From: Griffin, Tim (Contractor)
Sent: 14 May 2026 15:45
To: Altman, Rebecca
Cc: Oliveira, Marta (Contractor); Dyer, Tim; Ellison, Mark
Subject: DC/26/101166: Cockpit Farm Barn, Knowle Lane, Horton Heath, Eastleigh, SO50 7DZ
- landscape comments

Strategy Plan

Planting Plan sheet 1

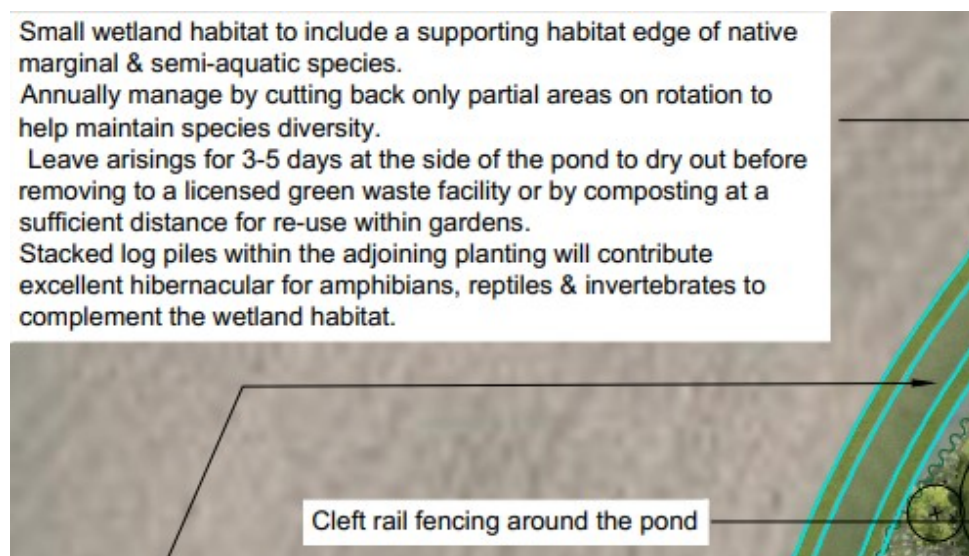
5/ *Populus canescens* is a large fast growing tree. Perhaps the single specimen close to Plot 6 should be changed to a medium sized tree to avoid complaints from future residents.

Planting Plan Sheet 2

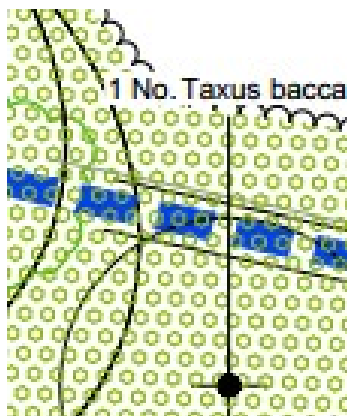
13/ Can this Yew be planted as it appears to be in an area of existing vegetation?
